To: Kristopher Byrd, Well Construction and Compliance Section Manager
From: Travis Kelly, Well Construction Compliance Coordinator
Subject: Review of Water Right Application G-19054
Date: February 16, 2022

Application # G- 19054

A. GENERAL INFORMATION: Applicant's Name: De Terra LLC/Richard W. Todd County: Clackamas

A1. Applicant(s) seek(s) 0.25 cfs from 1 well(s) in the Willamette Basin,
Middle Willamette/Clackamas subbasin

Well Statistics for Sections 3S/3E-28, 29, 32, and 33 and 4S/3E-4 and 5

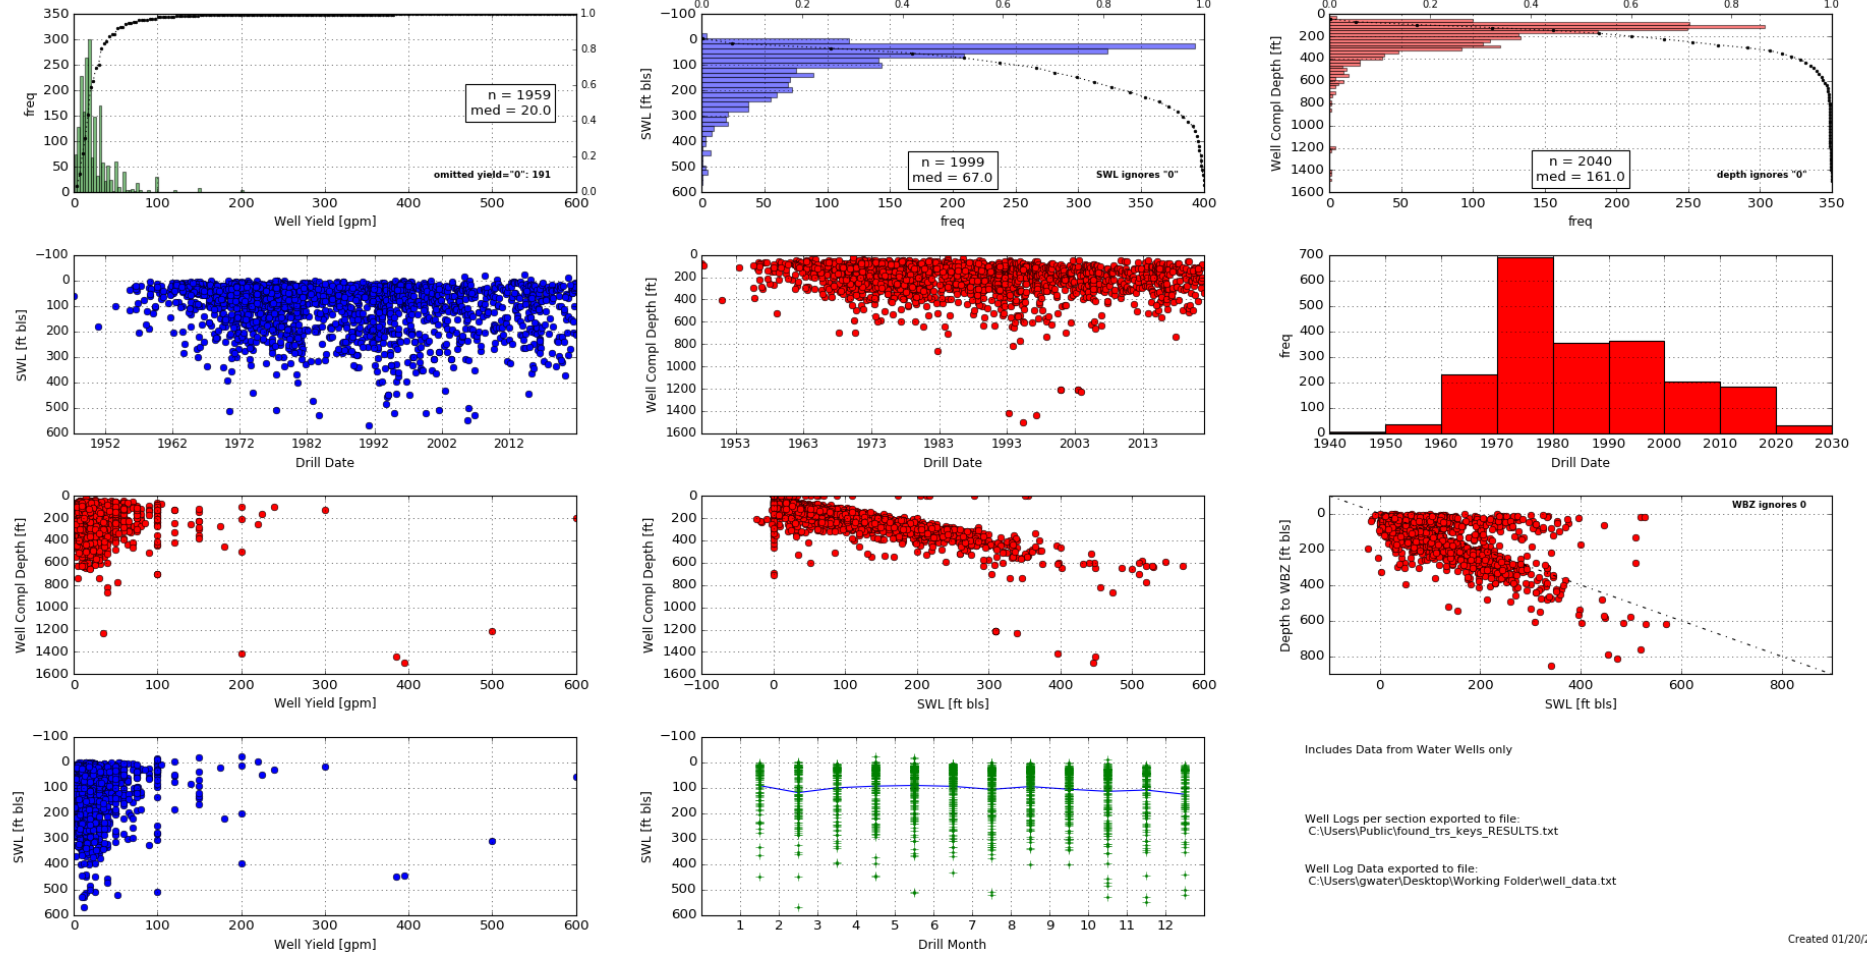
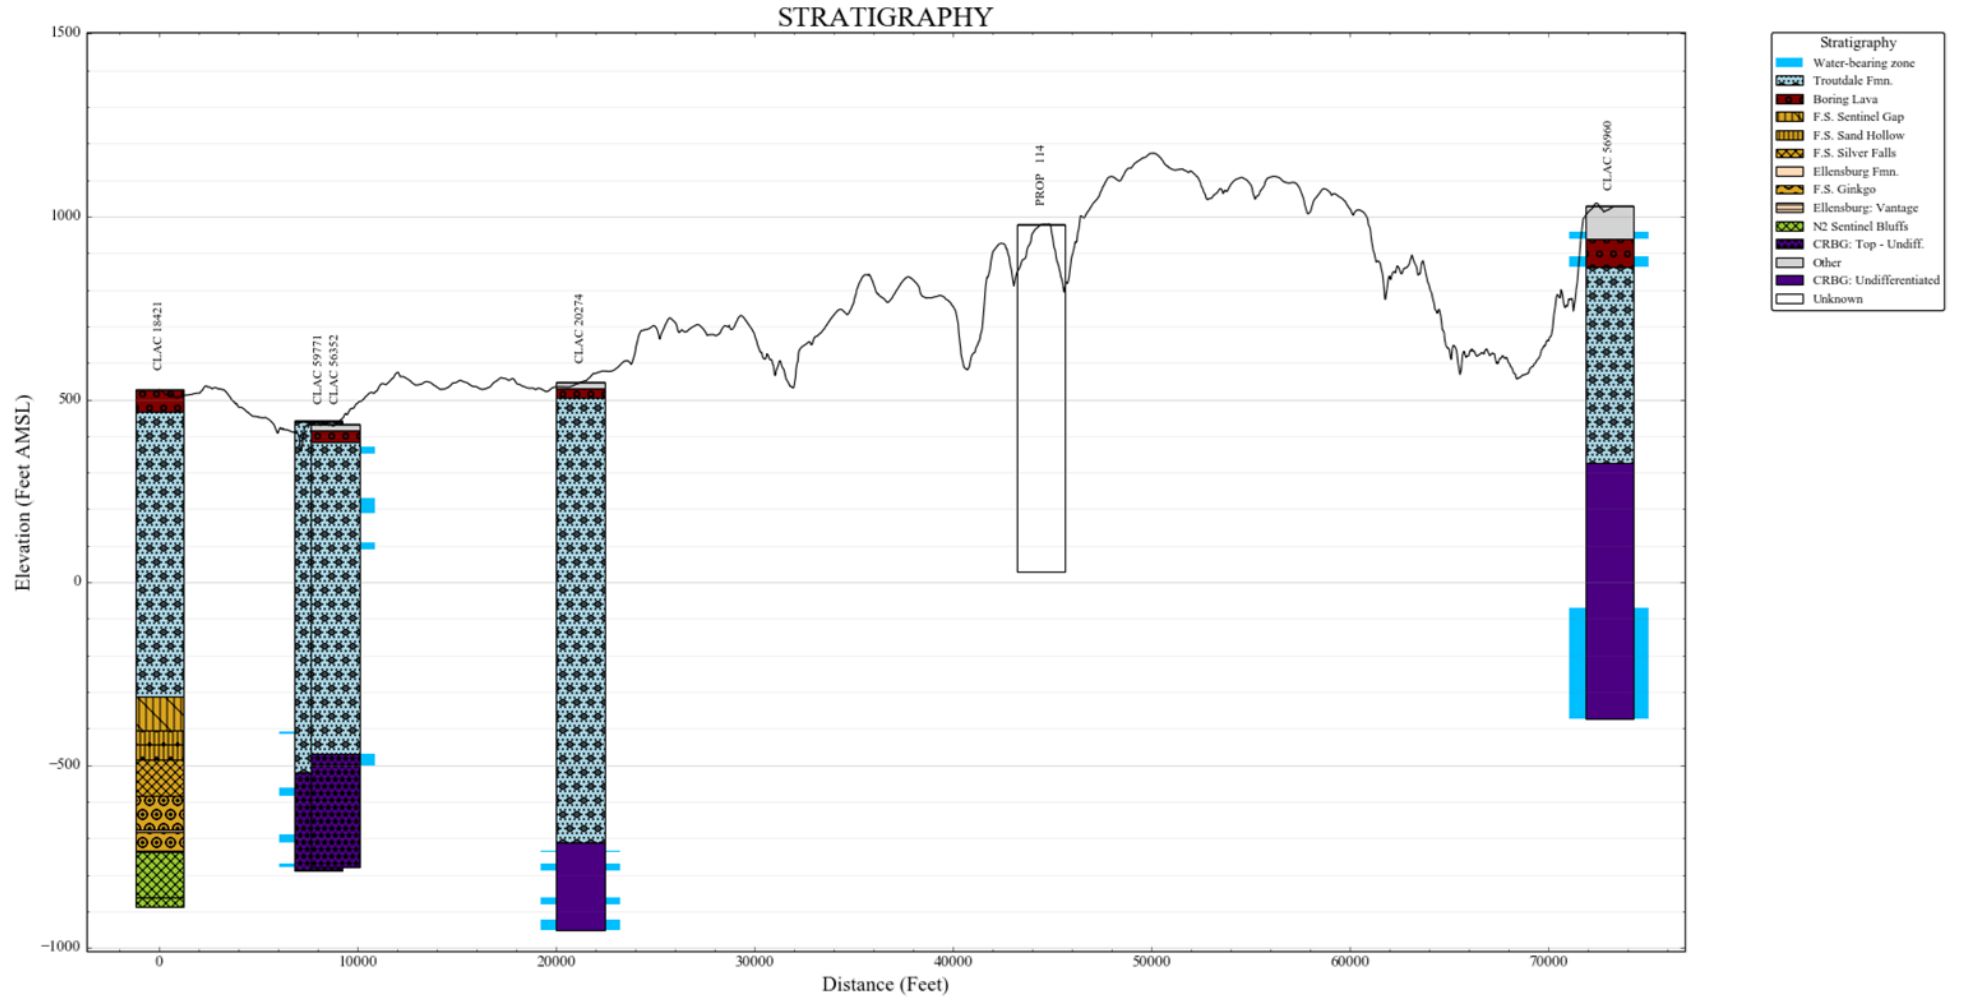
The proposed well is significantly deeper than existing nearby wells and therefore lithologic and water level data is sparse. The proposed rate (~112 gpm) is greater than most wells nearby (see attached well statistics), although data for deep CRB wells is sparse. Applicant identified CRB as the proposed aquifer, but regional geologic maps and well logs (see attached cross section) indicate that the top of the CRBs is between -200 and 0 ft above mean sea level, whereas the proposed well will reach a maximum depth of 29 ft above mean sea level. A well constructed as proposed will likely not produce from the proposed aquifer. A condition to allow groundwater production from no shallower than 980 ft below land surface is recommended to allow production only from the CRBs, but this number may change as more evidence (drill cuttings) becomes available regarding the actual depth of the CRBs.

Cross-section of nearby CRB wells

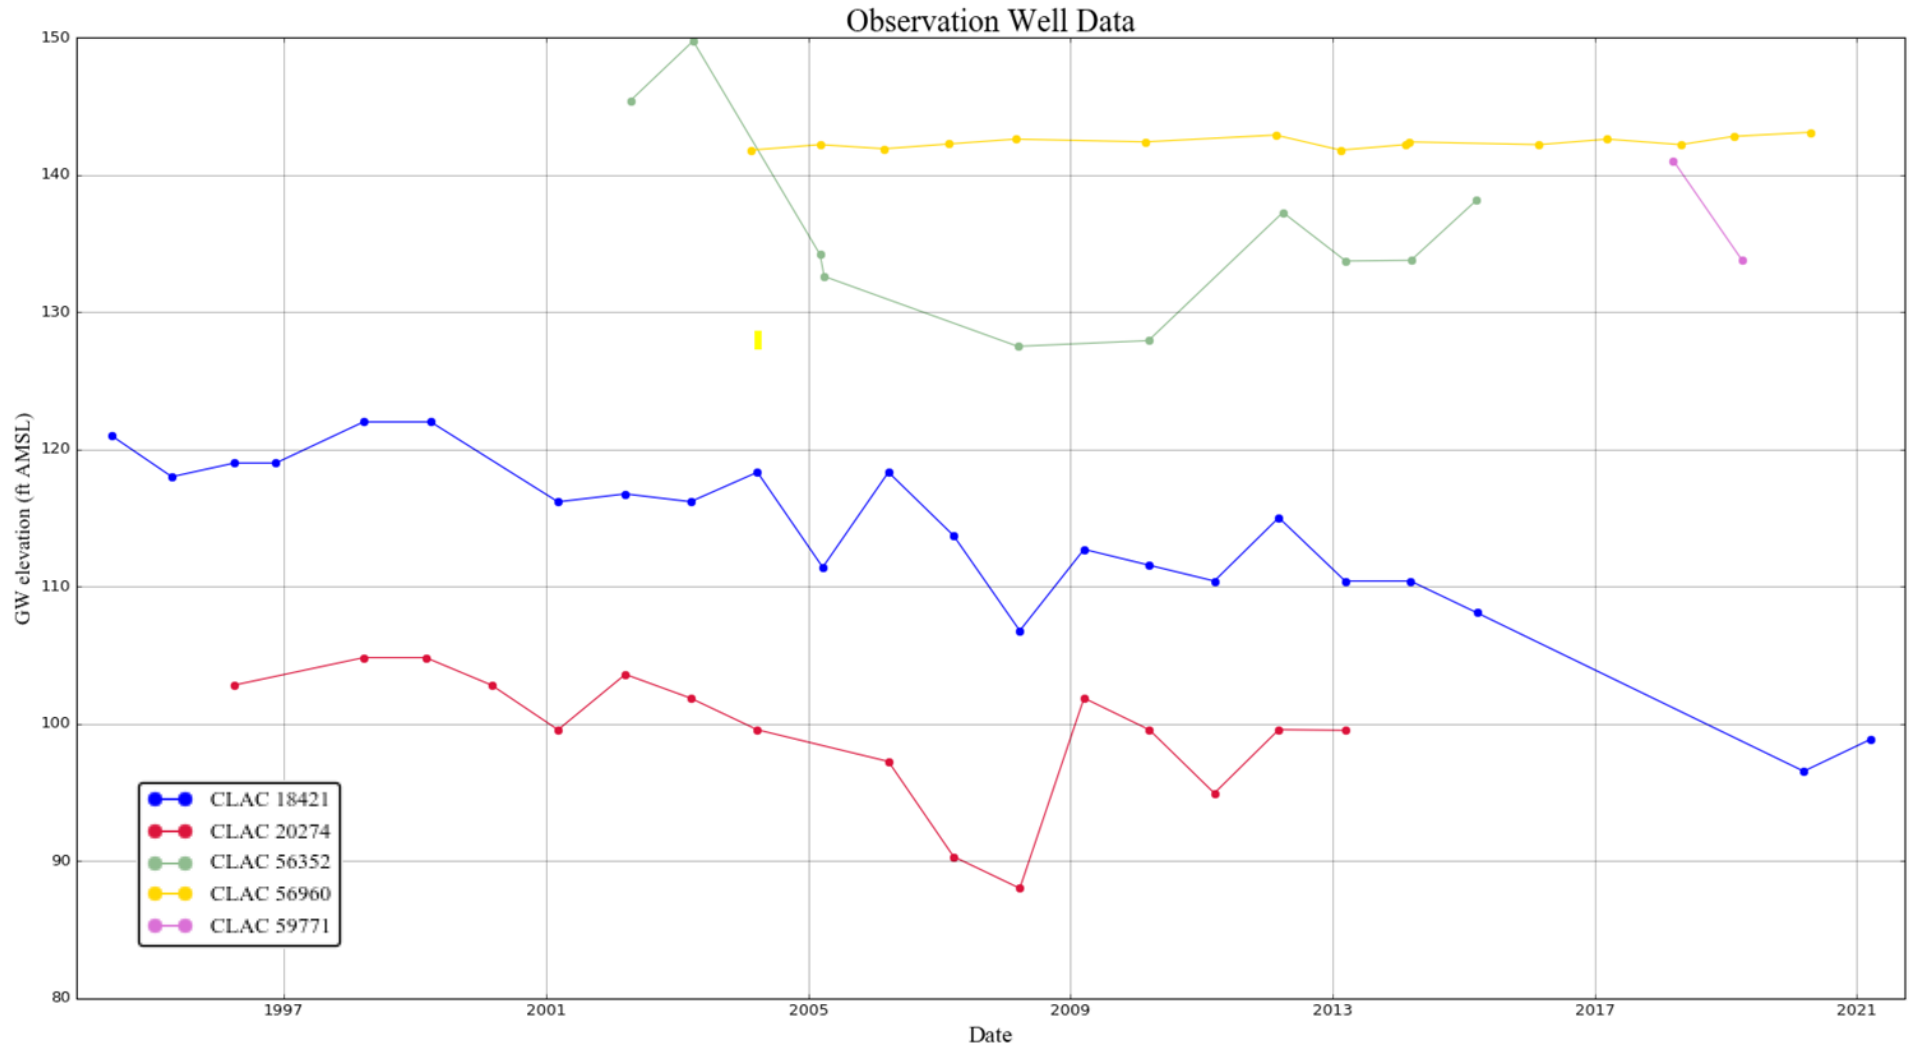
³Applicant stated approximately 350-400' based on "nearby deep CRB wells," however, nearby CRB wells (CLAC 18421, CLAC 20274, CLAC 56352, CLAC 56960, and CLAC 59771) indicate water level elevations closer to 90-150 ft above sea level, or roughly 830-890 ft below land surface at the applicant's proposed well.

Basis for aquifer confinement evaluation: Well proposed to draw from the Columbia River Basalt (CRB), locally overlain by the Troutdale Formation and Boring Lava. Water well reports for regional CRB wells (CLAC 18421, CLAC 59771, CLAC 56352, CLAC 20274, CLAC 56960) indicate water levels above the top of the relevant water-bearing zones, as do reports for shallower wells drawing from the Troutdale Formation. Based on the available evidence, the aquifer is confined.
